Product Change Notification / SYST-18YIFQ586

ERRATA - SmartFusion®2 Device Errata

Description of Change: Added 1.25. Avoid eNVM Page Lock and Unlock if Code is Being Executed from eNVM both in Release and Debug Mode

Figure 1-1. Cortex-M3 Core Register Set

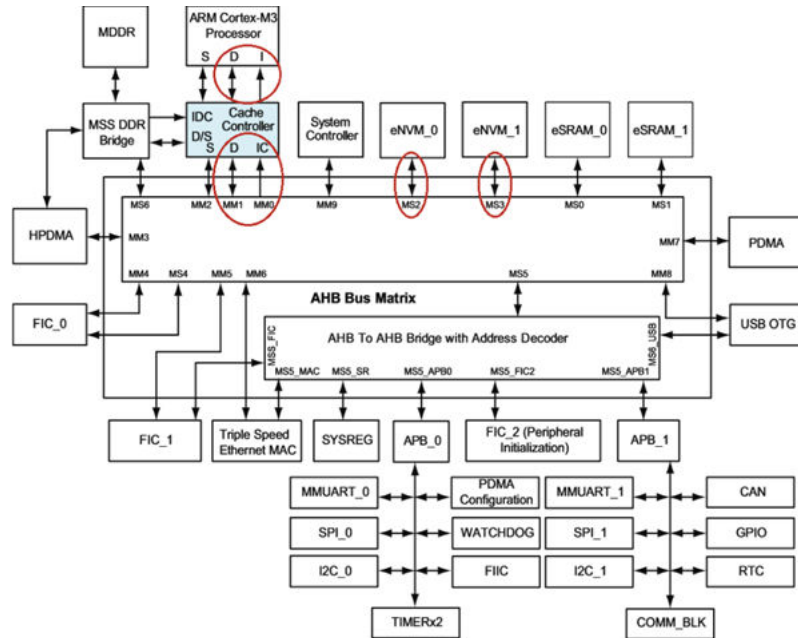
Cortex-M3 internal general-purpose registers (for example R6) gets corrupted when two nested D-Bus (must be a non-64-bit-aligned access) and I-Bus cache miss cycles occur in cache controller fetching from eNVM followed immediately by a D-Bus read without cache miss.

1. Add one the following compiling options depending on the toolchain used. This option prevents a D-Bus read to happen after I-Bus read. The following is a list of most common compilers used.
 - Keil, `--no_integer_literal_pools` or similar options
 - IAR, `--no_literal_pool`
 - GCC-ARM, `-mpure-code`
2. Recompile the code and update the executable code on the boot medium.
